UNITED STATES ENVIRONMENTAL PROTECTION AGENCY
WASHINGTON, D.C. 20460

A-98-49
II-A3-24

Thank you for your letter dated June 26, 2000, in which you notified us of your intent to raise the Waste Isolation Pilot Plant's repository horizon in Panels 3, 4, 5, 6, and 9 by approximately two meters so that the roof is located at Clay Seam G. My staff have reviewed your plan, and we agree that it will enhance operational safety without significantly affecting the long-term performance of the facility. A summary of our technical review is enclosed for your information. We will place this summary in our docket.

Summary: EPA Review of Clay Seam G Mining Plan

Figure 3-6. Location of Panel Closure System

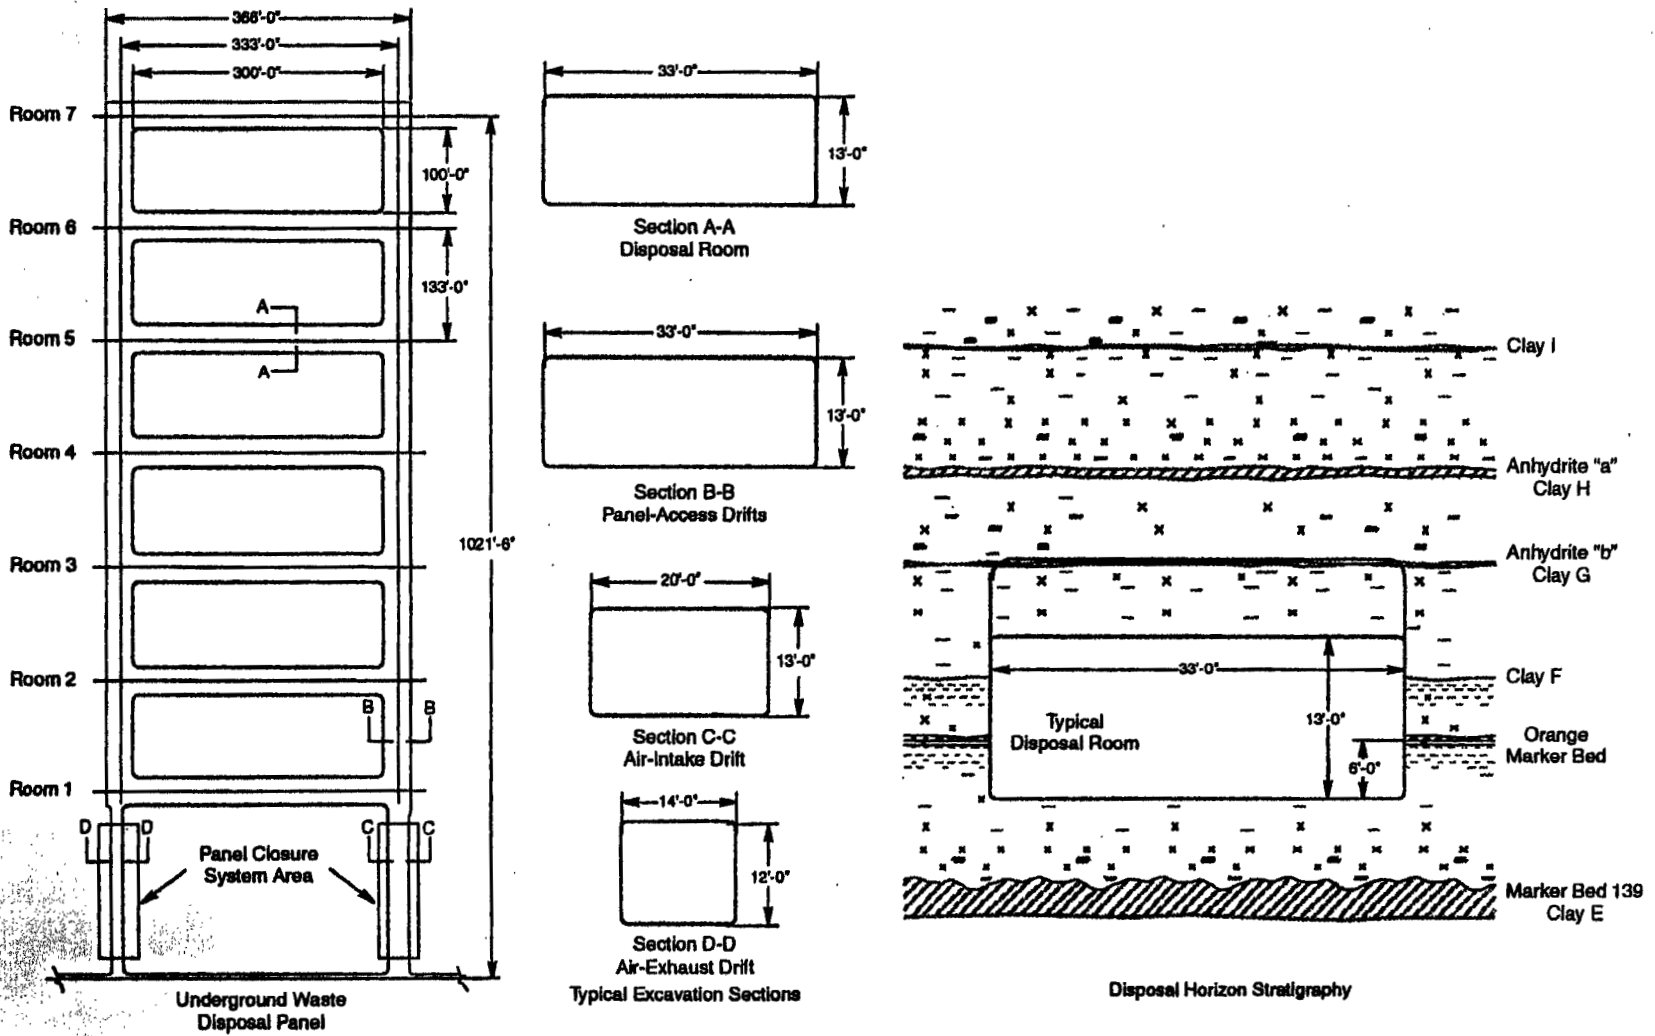
The repository horizon for Panels 3, 4, 5, 6, and 9 will be raised so that the roof is at clay seam G (shown on the attached Figure 3-6). Raising the repository horizon will be initiated in the East 300 drift (shown on the attached Figure 3-2) which leads into Panel 3. Raising the repository horizon now and in this location will result in improvements in safety and in operational efficiencies. This does not imply that there are underground safety concerns associated with the present situation; however, by raising the repository horizon by about two meters, ground conditions will be improved and considerably less maintenance will be required to assure optimum ground conditions.

Figure 25
Model Results for E140 Drift With Roof Beam Removed

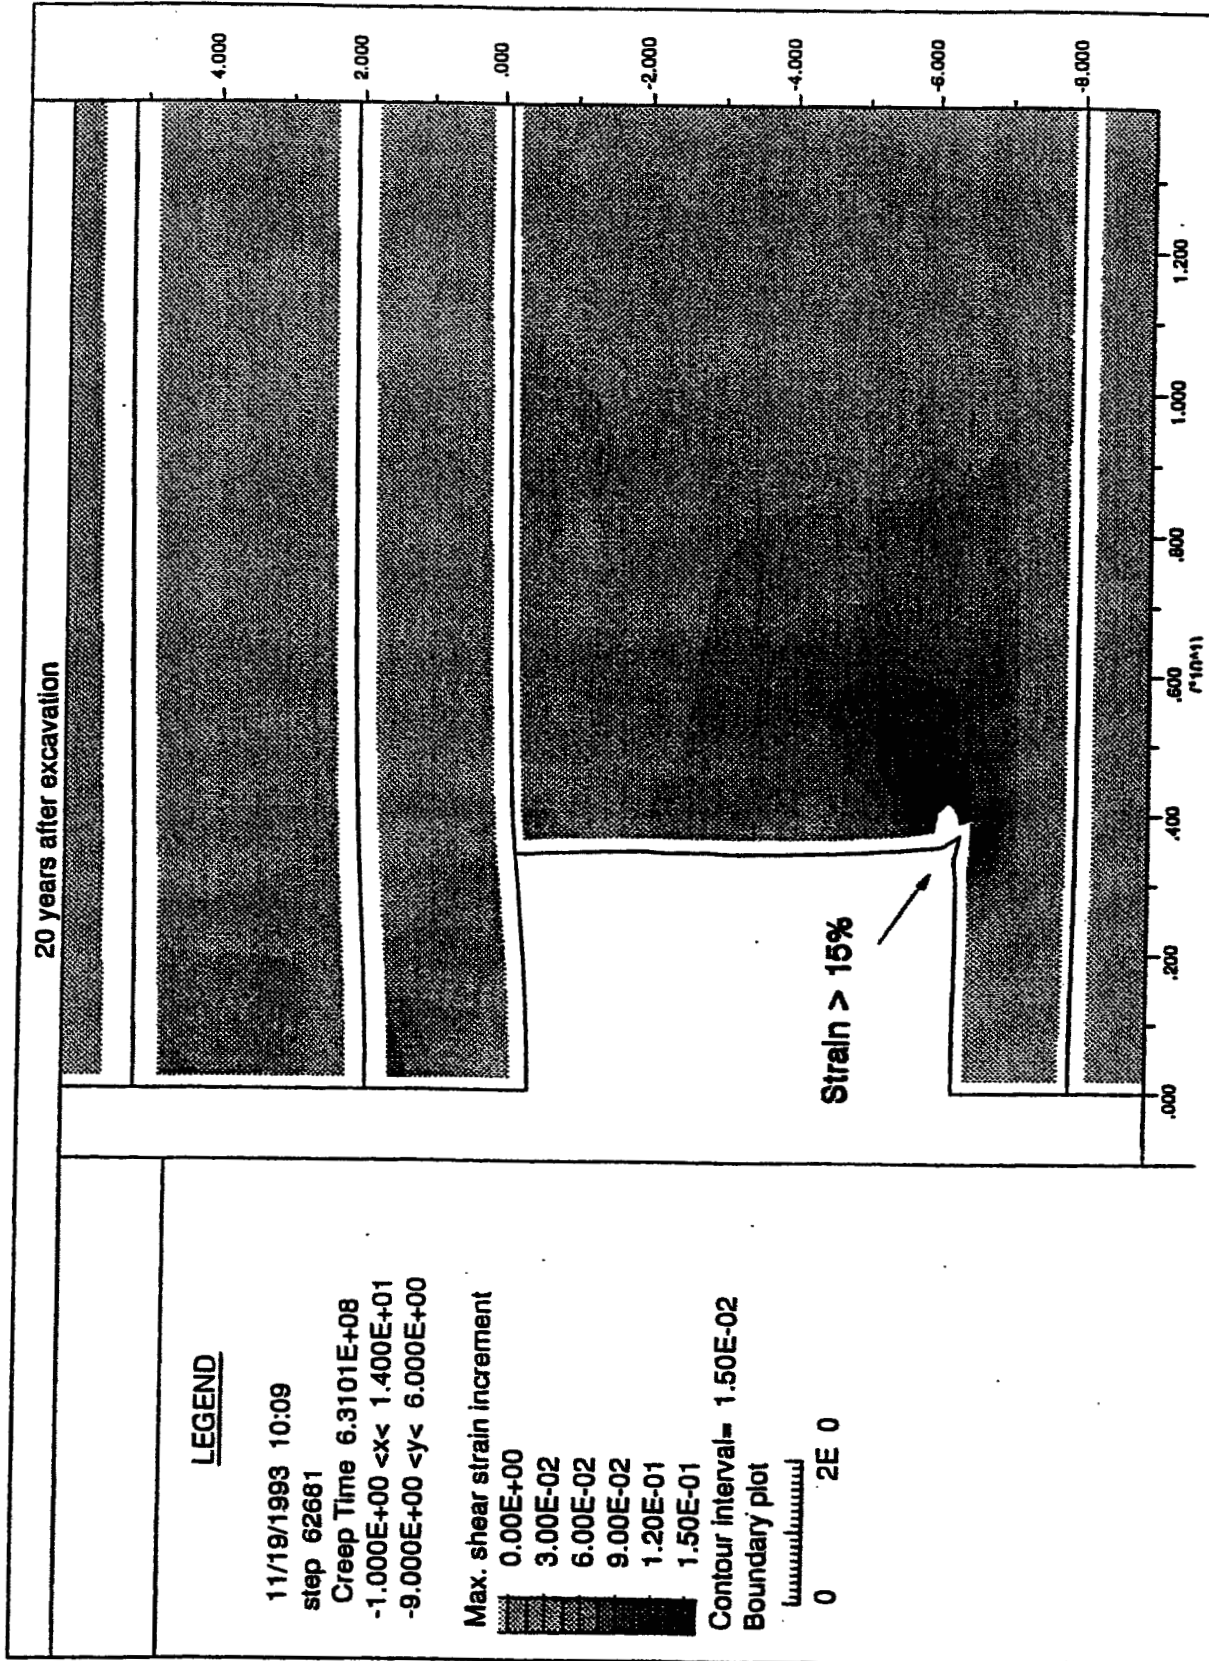
These results are supported by numerical modeling, which shows a transfer of lateral stresses to the floor (DOE-WIPP 94-025, Figure 25). Although the strain in the corner between the floor and the sidewall considerably increases, the resultant fracturing is at the floor and is not considered hazardous, because it can be readily supported if needed in the same manner as the fractured halite presently observed at the corners of drift intersections.
